## Product Change Notice (PCN)

**PCN Number:** PCN-0456166R

Product(s) Affected: *PJ-036CH*

PREVIOUS CUI DEVICES DETAIL / IMAGE	NEW CUI DEVICES DETAIL / IMAGE

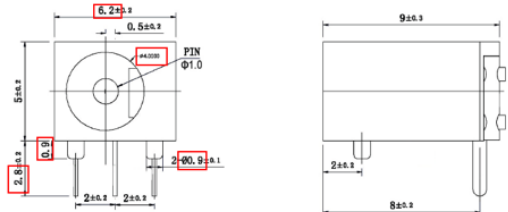
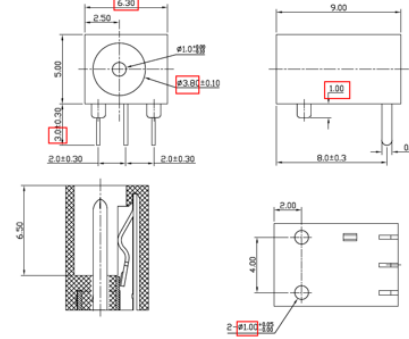
Description of Change: *New Factory Location. Product re-engineered for improved manufacturability and production yield. See image below for reference and check CUI Devices website for updated drawing. Cosmetic differences may be visible and not affect the form fit and function of the product.*

PREVIOUS CUI DEVICE'S DETAIL / IMAGE			NEW CUI DEVICE'S DETAIL / IMAGE		
DESCRIPTION	MATERIAL	PLATING/COLOR	DESCRIPTION	MATERIAL	PLATING/COLOR
center pin	brass	silver	center pin	brass	silver
terminal 1	brass t=0.25	silver	terminal 1	brass t=0.25	silver
terminal 2	brass t=0.25	silver	terminal 2	SUS301 t=0.25	silver
terminal 3	brass t=0.25	silver	terminal 3	brass t=0.25	silver
housing	PBT (UL94V-0)	black	housing	PPA (UL94V-0)	black

<p>MATING PLUG Jack Insertion Depth: 6.4 mm</p>	 <p>MATING PLUG Jack Insertion Depth: 6.5 mm</p>
---	--
